SECTION 00 9115
ADDENDUM NUMBER 5

DATE: August 11, 2016

Rochester City School District
 James Monroe High School
 164 Alexander Street
 Rochester, New York
 SED #: 26-16-00-01-0-107-029
 DWT #: 26-16-00-01-7-999-019

PROJECT: **RSMP - JAMES MONROE HIGH SCHOOL**
 PHASE 2A
 DRAWING TITLE: **SECTION AT INFILL FRAME SUPPORT**
 PROJECT NO: 1522
 DRAWN BY: MR
 SCALE: AS NOTED
 ISSUE DATE: 8/10/16
 REVISION DATE:

1 BASEMENT DEMOLITION PLAN
D100 SCALE: 1" = 20'

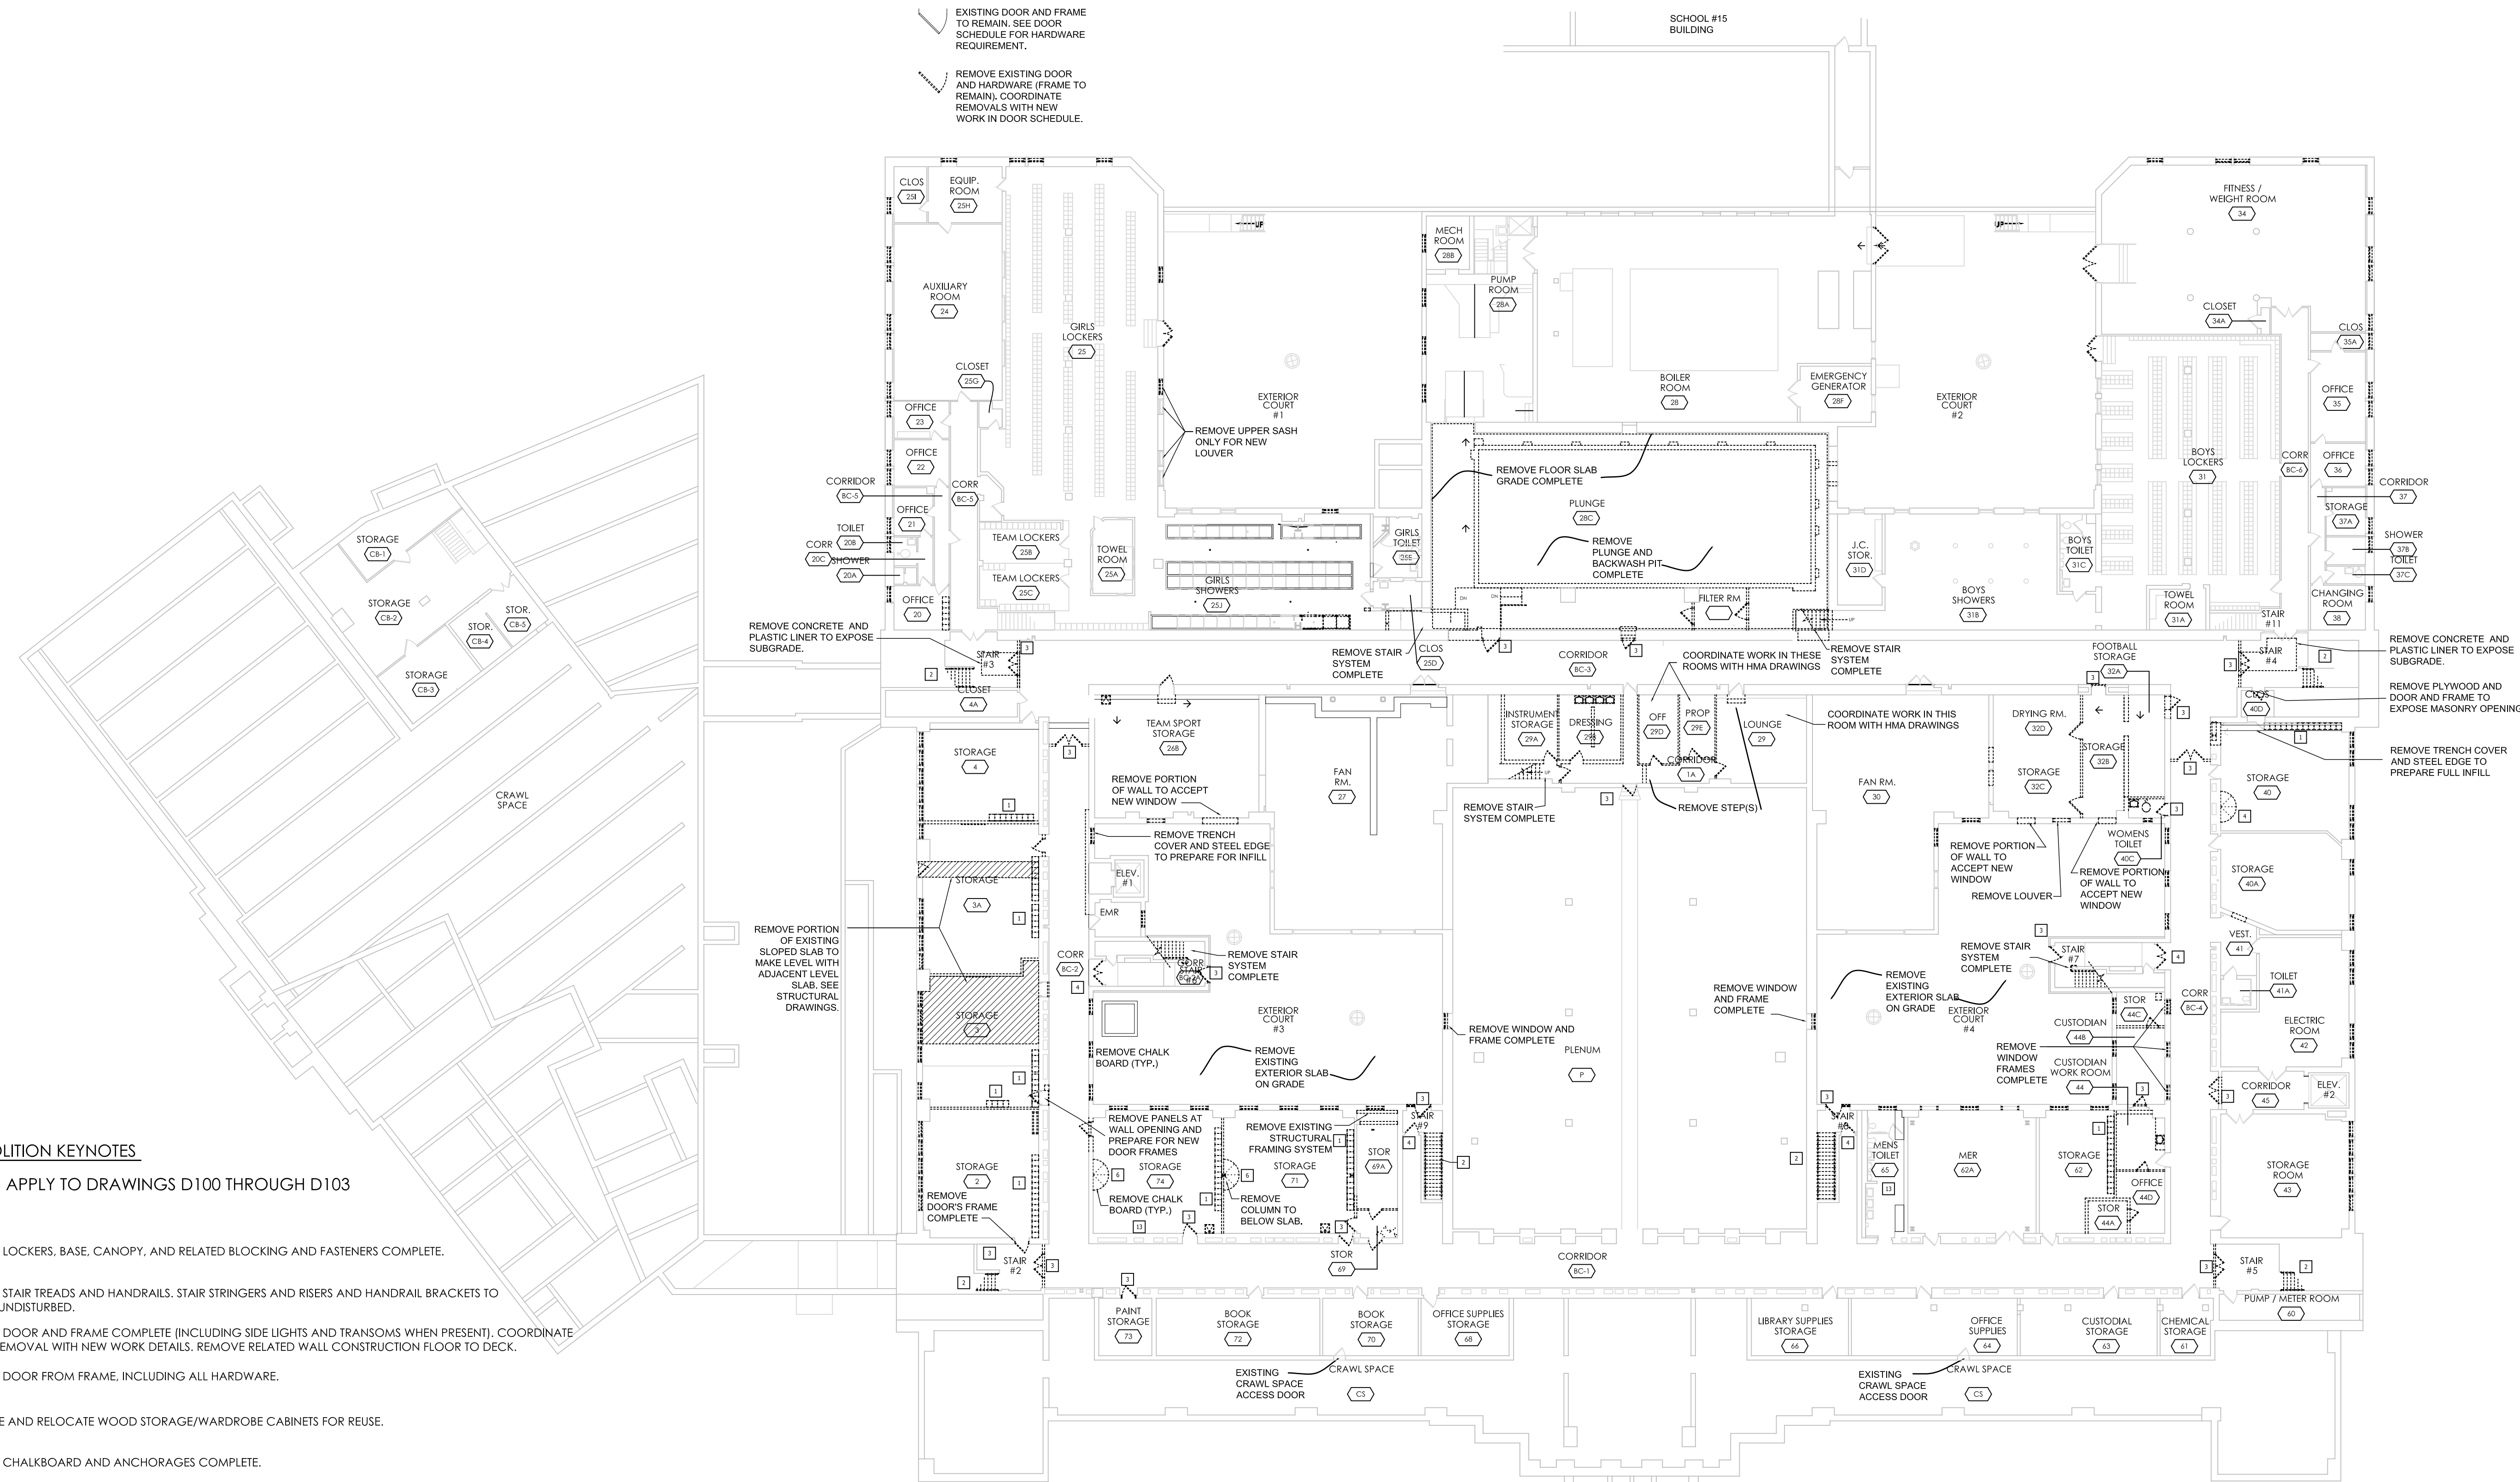
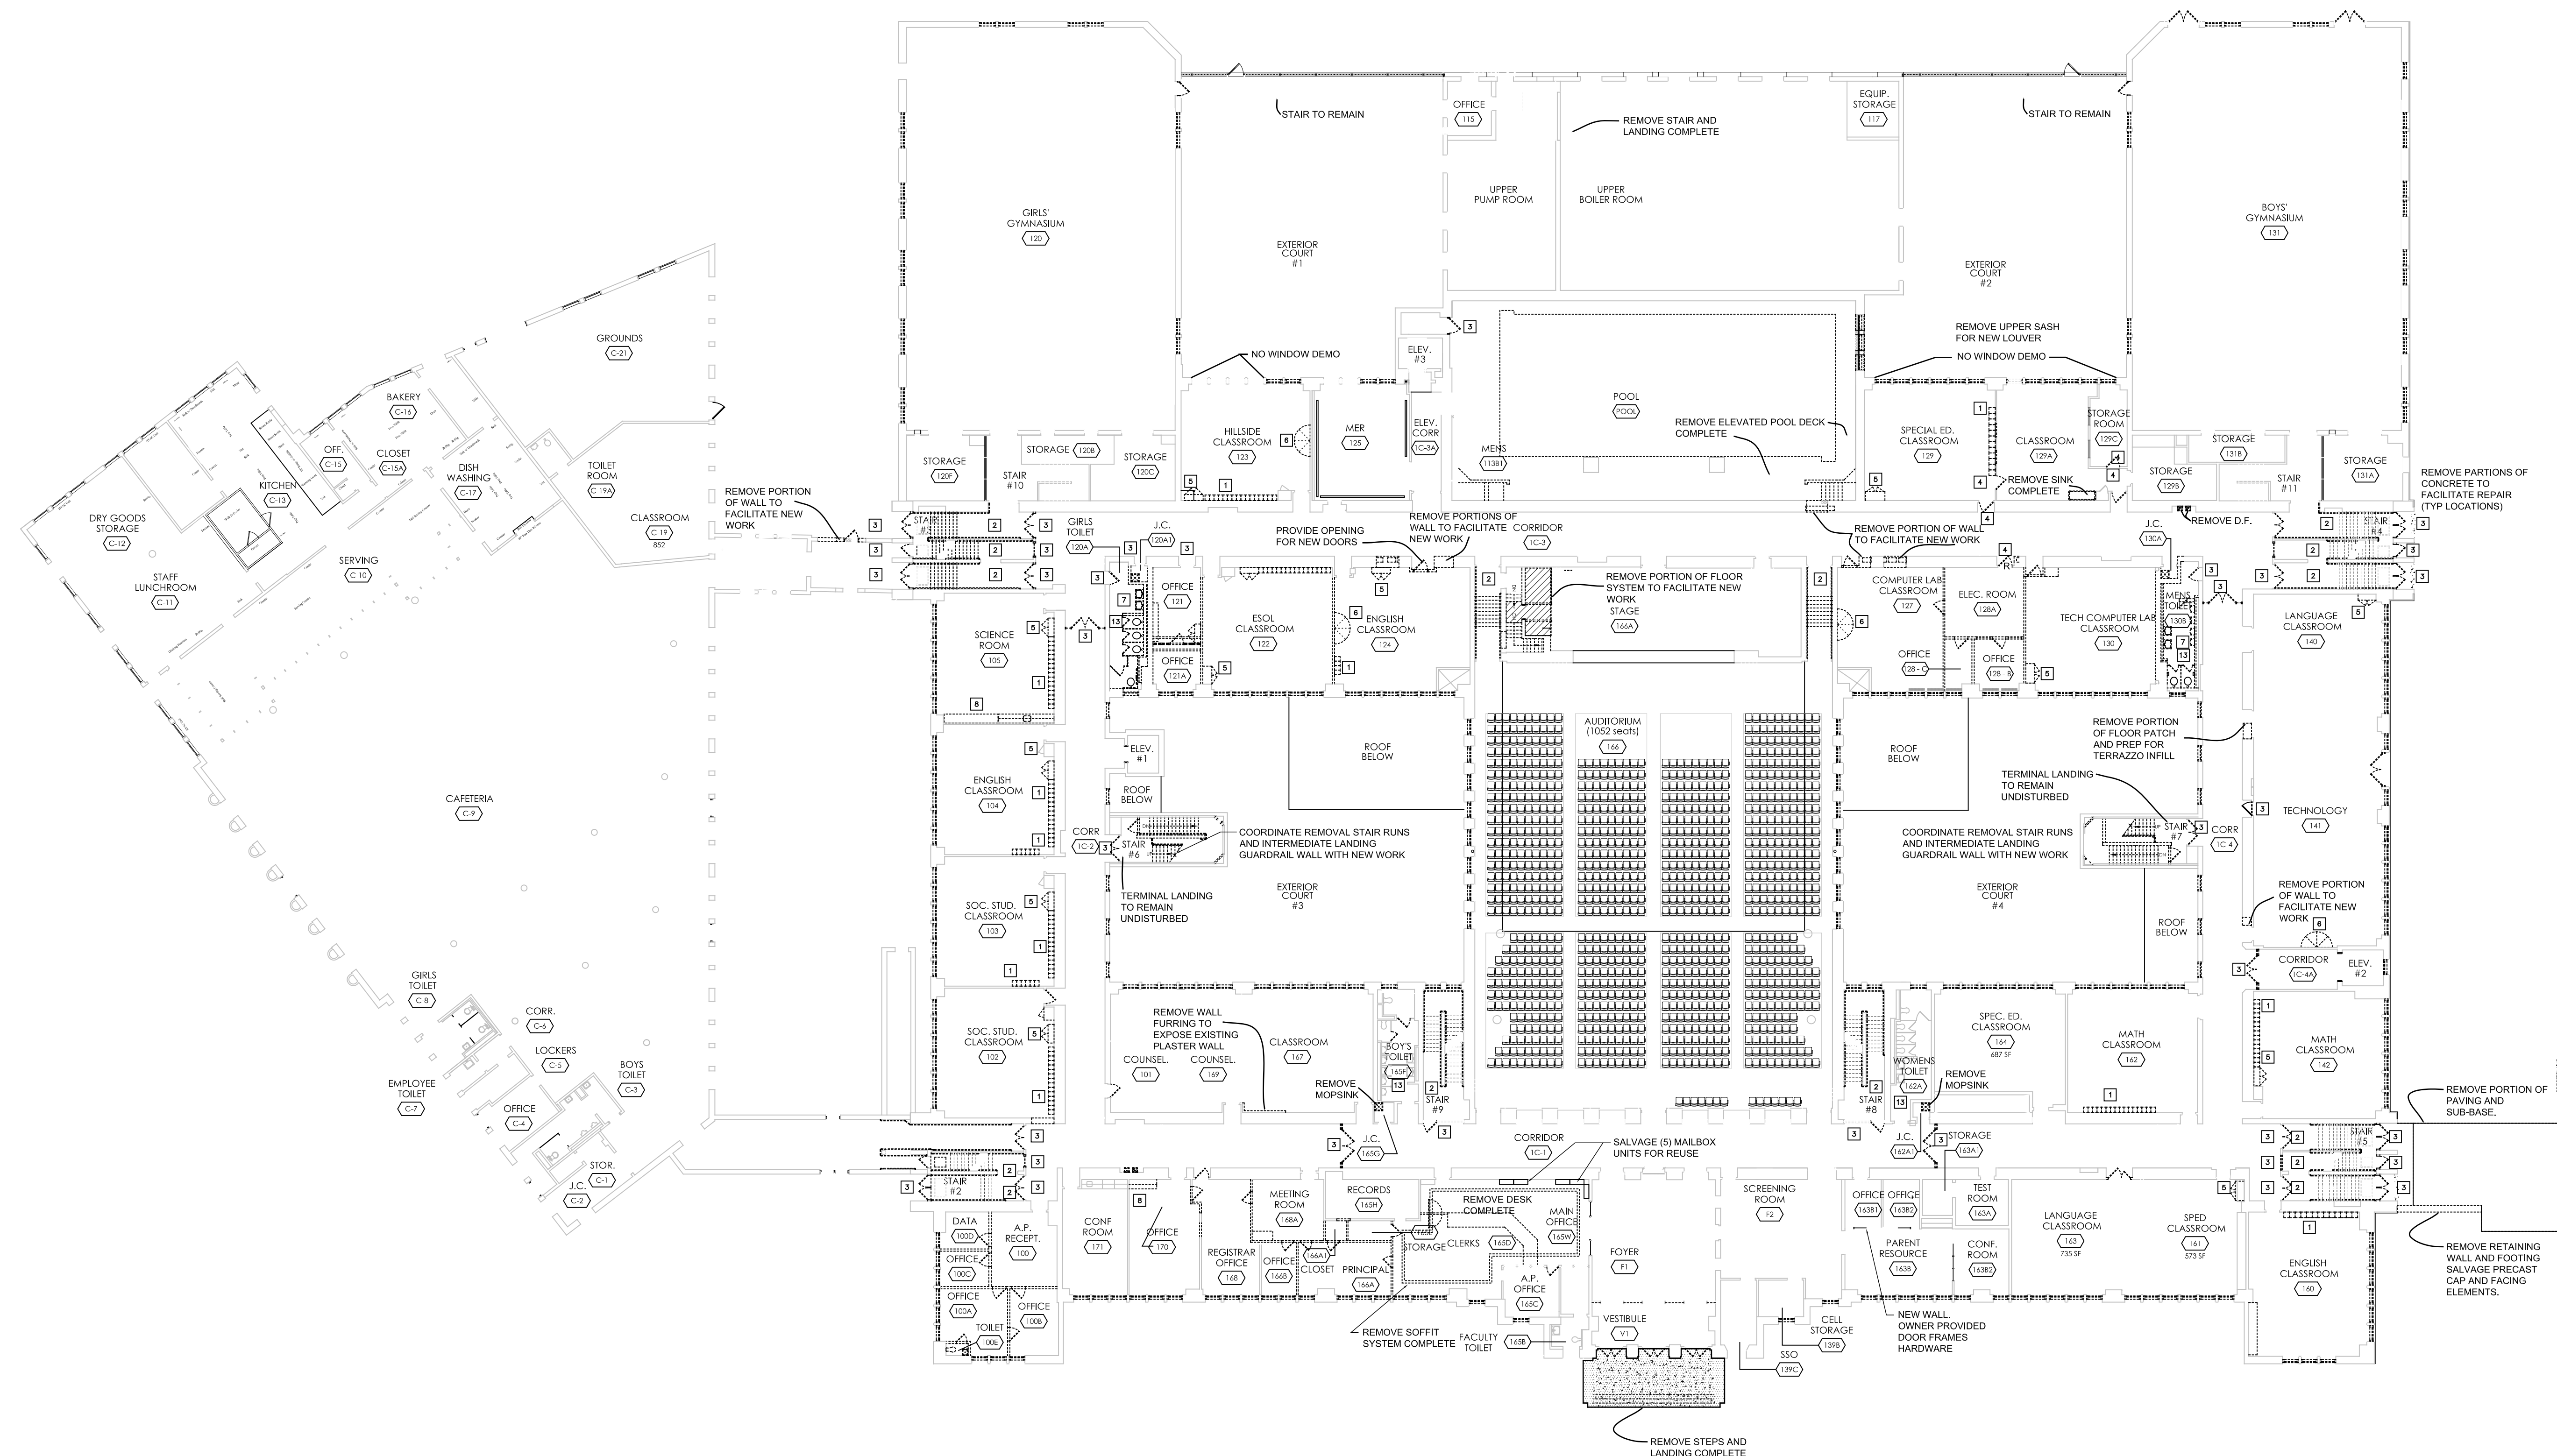
- A. Demolition Keynote 2: Add the following "Alternate No GC-02."
B. Demolition Keynote 14: Replace in its entirety with the following:
"14. Remove existing finish flooring to expose plywood substrate. Repair and patch plywood substrate as required to receive new floor finish. Where science room extension laboratory tables (with legs) exist, remove legs to facilitate extending new finish floor under legs. Reinstall legs after floor completion. "
